# HISTORIC AND DESIGN REVIEW COMMISSION

**HDRC CASE NO:** 2020-335  
**ADDRESS:** 529 N PALMETTO  
**LEGAL DESCRIPTION:** NCB 1371 BLK 3 LOT 29 & 30  
**ZONING:** RM-4, H  
**CITY COUNCIL DIST.:** 2  
**DISTRICT:** Dignowity Hill Historic District  
**APPLICANT:** Abigail Arispe/GALLEGO LAZARO A & OZUNA LILLIAN  
**OWNER:** Abigail Arispe/GALLEGO LAZARO A & OZUNA LILLIAN  
**TYPE OF WORK:** Removal of brick chimney  
**APPLICATION RECEIVED:** July 20, 2020  
**60-DAY REVIEW:** Not applicable due to City Council Emergency Orders  
**CASE MANAGER:** Huy Pham

The applicant is requesting a Certificate of Appropriateness for approval to remove the existing brick chimney.

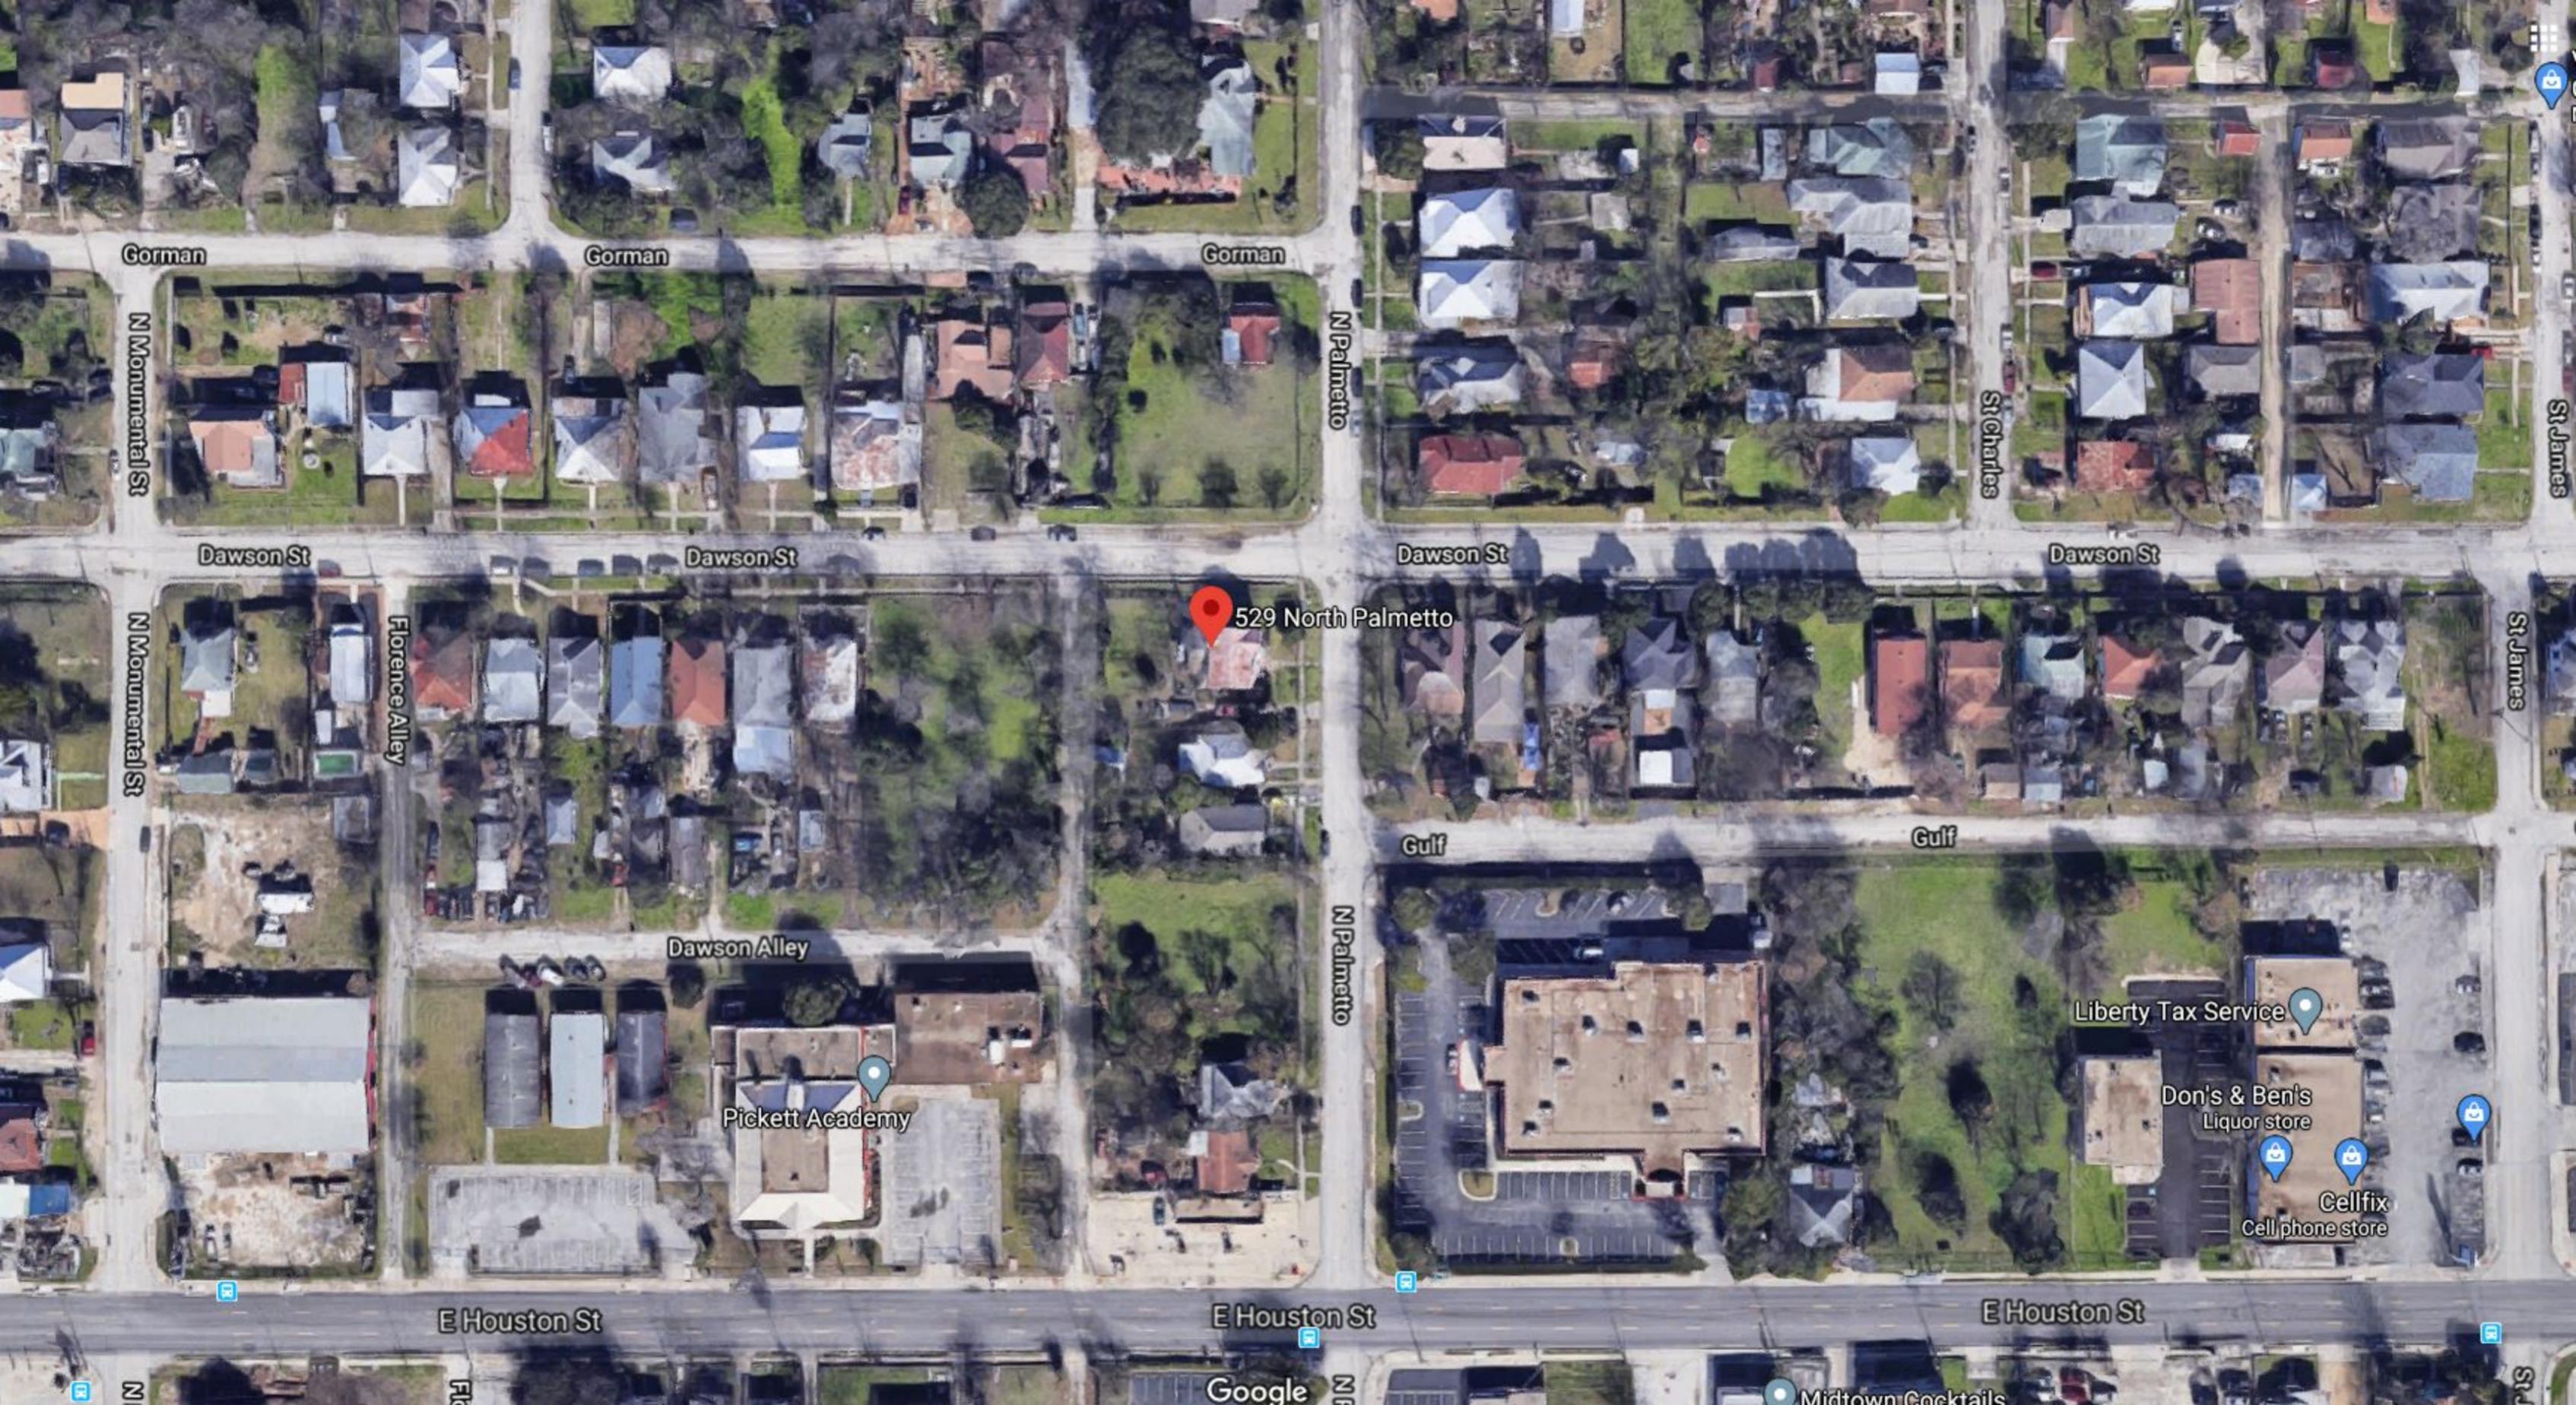
- b. CHIMNEY – The applicant has proposed to remove the brick chimney located on the north façade facing Dawson. The chimney features fully exposed brick construction with a tapered crown, stepped shoulders on the exterior of the mantle, and white paint finish. The chimney has begun buckling most at the mantle. Staff finds that the chimney is a character-defining feature of the structure and while it may be temporary deconstructed during structural repairs of the primary structure, it should be reconstructed based photo-documentation and a measured drawing submitted to staff.

Staff does not recommend chimney removal based on finding b. If temporary removal is required for structural repairs on the primary structure, staff recommends the chimney is reconstructed in-kind with the following stipulations:

1. That the chimney is deconstructed to salvage and reuse as many original bricks as possible
2. That no work is performed prior to submitting thorough photo-documentation and a measured drawing of the chimney.
